Product Change Notification - SYST-04GTSX528

ERRATA - PIC32MK Motor Control and General Purpose Errata and Data Sheet Clarification

Description of Change: 1) Updated verbiage for Silicon Issue 39. (UART). 2) Added Silicon Issues: 55. (PMD Bits) and 56. (DAC) 3) Removed Silicon Issue 6. (Reserved) and 17. (Reserved).

PIC32MK General Purpose and Motor Control (GP/MC) Silicon Errata and Data Sheet Clarification

FIGURE 1: POSC CRYSTAL CIRCUIT

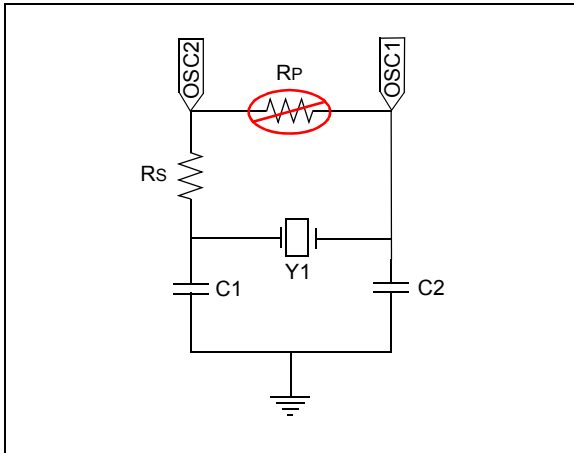
1. Module: Primary Oscillator

The POSC supports only specific crystal operation as provided in [Table 1](#).

The Primary Oscillator (POSC) has been characterized to operate at 8 MHz and 12 MHz when the circuit shown in [Figure 1](#) is implemented and the operating conditions provided in [Table 1](#) are met.

FIGURE 2: RESET SUPERVISOR CIRCUIT

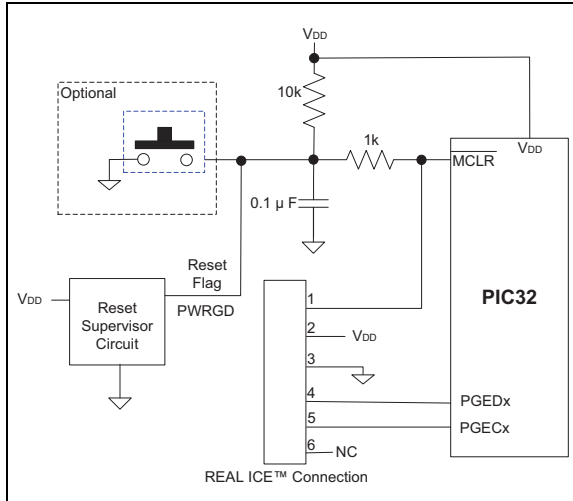
On a BOR event, $V_{POR} < V_{DD} < V_{BOR}$, a Reset is not generated when the BOR threshold is reached. System clocks will stop with all I/O pins functions frozen in their present state until either VDD falls to V_{POR} or VDD returns to above V_{BOR} . The user must assess if this VDD brown-out condition and the resulting frozen I/O pin state has an adverse effect on their application (UART, PWM, I/O, OC, etc.).

Use an external Reset supervisor/monitor (see Figure 2). Some LDO regulators, as listed in Table 4, have an embedded reset supervisor included. The required minimum reset trip voltage of the supervisor should be at least $(V_{BOR} + 0.5V)$ with the SMCLR bit (DEVCFG0<15>) = 0 and the BORSEL bit (DEVCFG2<29>) = 1 in the Configuration Words. This means that the minimum VDD operating voltage of the application needs to be above the reset supervisor maximum trip voltage at [Reset Trip (max) + 0.2V], (i.e. Application $V_{DD(MIN)} = \sim(V_{BOR} + 0.5V + 0.2V)$). The reset supervisor should have an open drain output so as not to interfere with the MPLAB programming/debug tools. This workaround assures that MCLR will generate an internal POR and reset the I/O pins before the V_{BOR} trip point.
